**APPLICATION AS NOTIFIED**

**(RM210657)**

### **SERVICE OF NOTICE / LIMITED NOTIFICATION**

**RM210657 – REQUEST FOR FURTHER INFORMATION RESPONSE**

ELEVATIONS. 1:100.

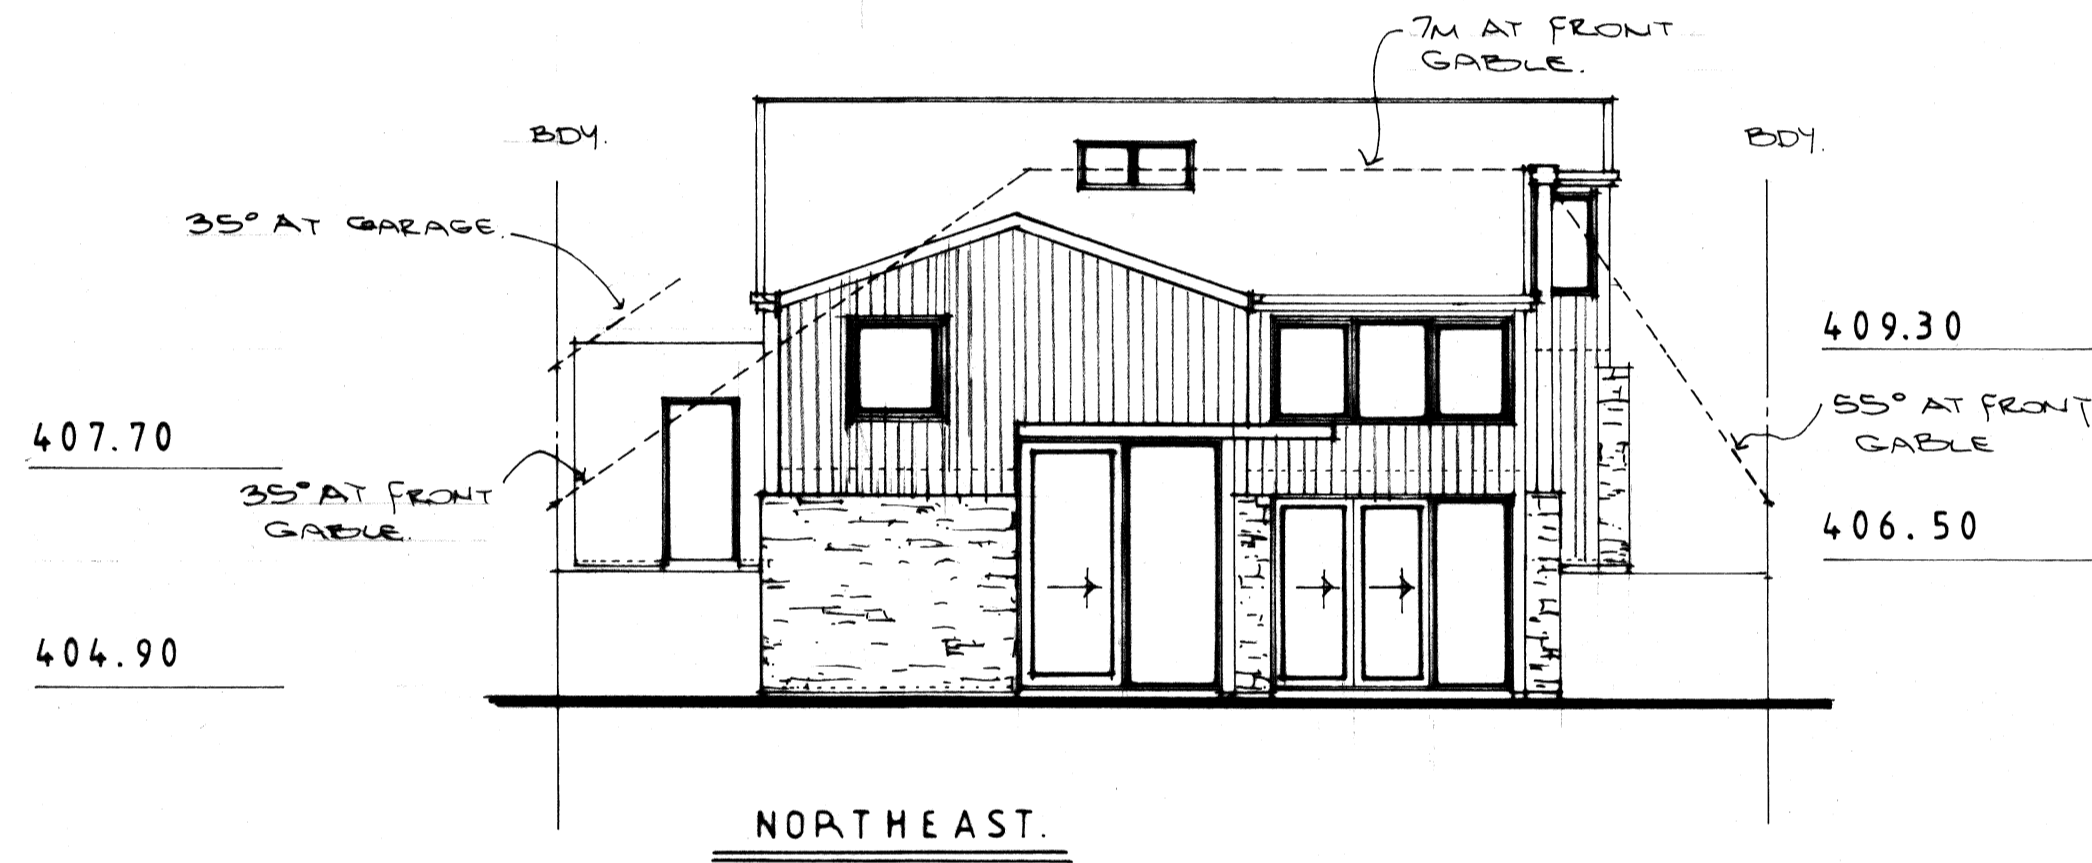
4. In order to fully assess the effects of the height in relation to boundary infringements, could you please provide amended versions of the south eastern and north western elevations on sheet A1-03 showing the extent of the height plane angle infringements that run along the length of the dwelling (shown in blue on the Aurum Survey plan but not on the architectural plans).

4. In order to fully assess the effects of the height in relation to boundary infringements, could you please provide amended versions of the south eastern and north western elevations on sheet A1-03 showing the extent of the height plane angle infringements that run along the length of the dwelling (shown in blue on the Aurum Survey plan but not on the architectural plans).

See attached plans.

From the northwest elevation (adjacent to 5 Devon Street), the maximum breach of the infringement is 1.2 metres. The recession plane breach extends along the length of the building by approximately 6.9 metres with the majority of this breach under 1 metre in height (with the exception of the breach at the gable). The boundary between 5 and 7 Devon Street is 31.78 metres. Taking into consideration the length of this boundary and the overall scale of the recession plane breach, it is assessed potential effects relating to dominance and loss of amenity will be less than minor.

From the southwest elevation (adjacent to 9 Devon Street), the maximum breach of the recession plane breach is 1.6 metres at the southern gable. The recession plane breach continues the length of the building and breaches by a maximum of 700mm along the northern half of the building. The residential unit (excluding the garage) has a total length of 19 metres adjacent to 9 Devon Street. The total length of the boundary here is also 31.78 metres. Effects relating to the recession plane breach are mitigated by the bulk of the building being set back 2.5 metres from the boundary, as opposed to the permitted 1.5 metres. This will create a sense of openness and space between the two sites. In addition, a large area of the northern part of the site will remain vacant of built form. This will allow appropriate solar access to be retained at 9 Devon Street. The area that is free of built form on the subject site will also contribute positively to the overall amenity for the owners and occupiers of 9 Devon Street. Containing the recession plane breach within the southern portion of the site is considered to appropriately mitigate potential adverse residential amenity effects. A much longer building, closer to the boundary could be constructed alongside this boundary. While such building would be slightly lower in height to meet recession plane requirements, having a building constructed along the length of the boundary, at a distance of 1.5 metres from this boundary, would likely impact the owners of 9 Devon Street in a more significant way than the current design. It is assessed that this setback, along with the open space at the northern portion of the site, is sufficient to mitigate the recession plane breach.
